**REQUEST FOR TENDER
ORANGUTAN OUTDOOR EXHIBIT CONSTRUCTION
RFT#: TZC T 10-2020-02
ADDENDUM # 2**

Date Issued: 2020 March 13
Project Name: **Toronto Zoo Orangutan Outdoor Exhibits**
To: Ben Knoop
Toronto Zoo
361A Old Finch Avenue
Toronto, ON M1B 5K7
Project Number: 18-1-086
RFT Reference No.: TZC-T-10-2020-02 (issued 2020-02-18)

ADD #A002

3 BARRIER FENCE AT DAYROOM
 AR-111 SCALE - 1:20

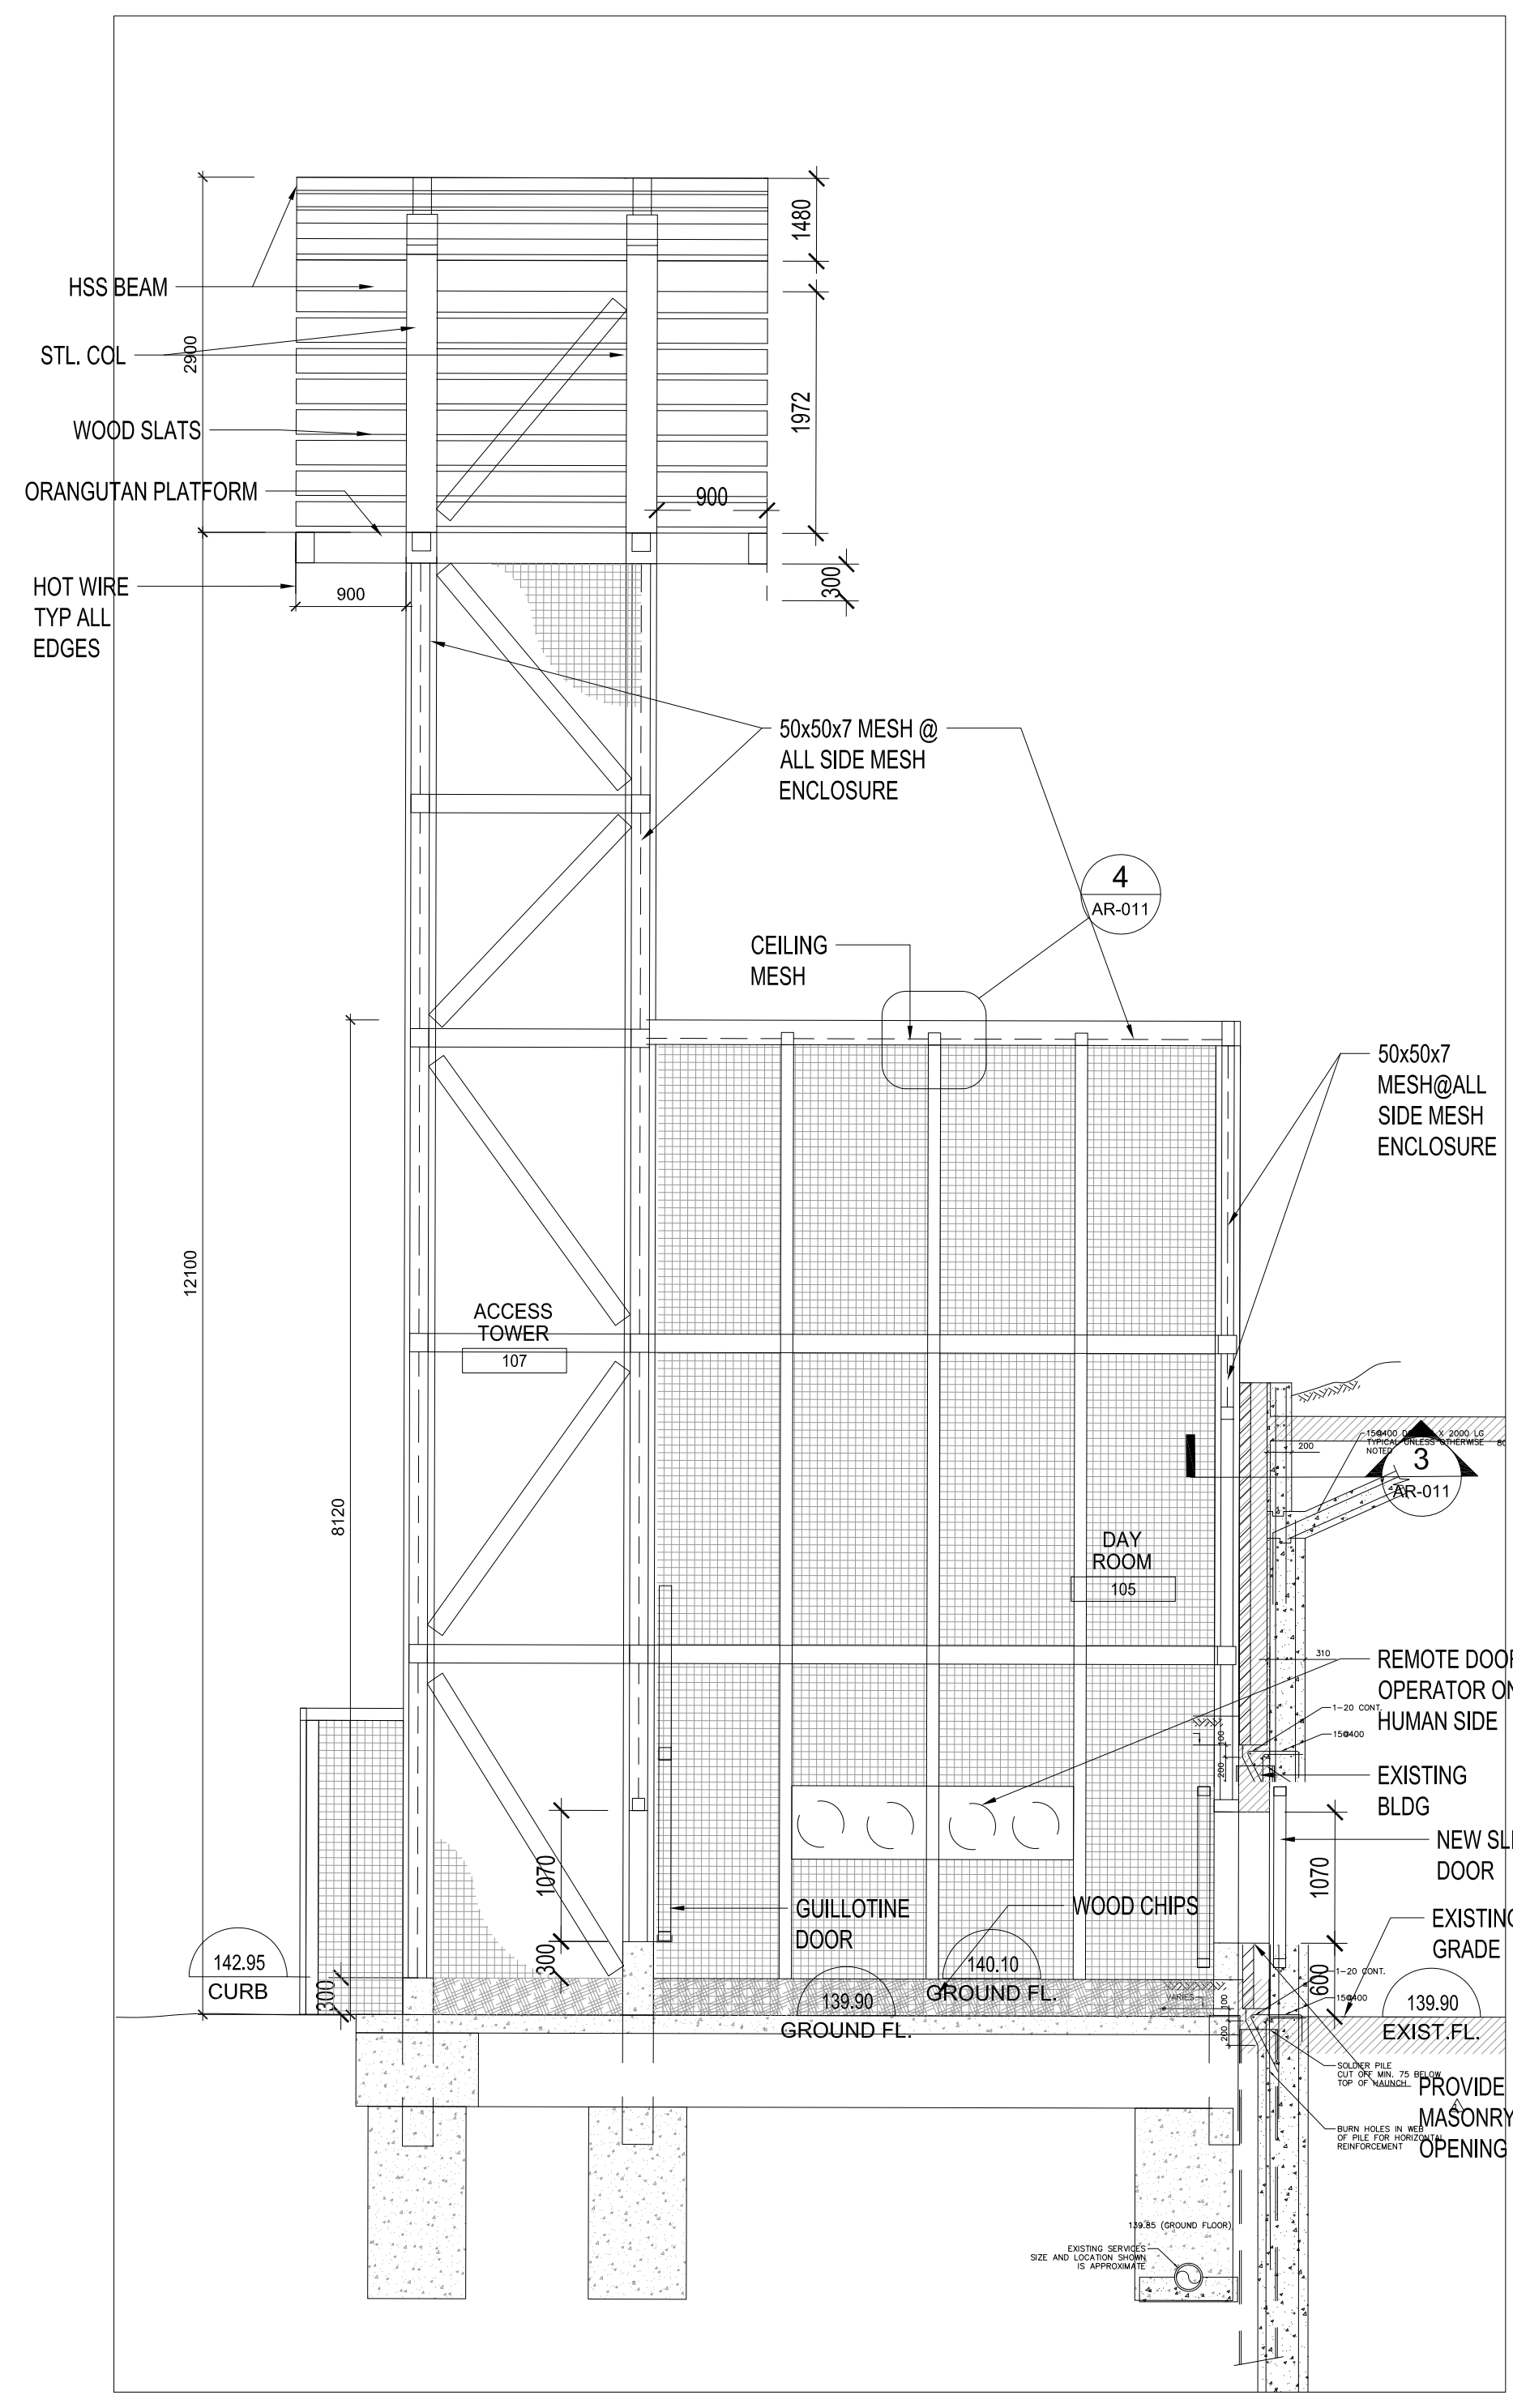
03.06.A	2020.03.06	A	9-Mar		
1 (A)	1	Barrier fence at day room landscaping detail is different than architectural detail	Zeidler	Follow Landscape detail (4/LA4); will revise the same in Arch.
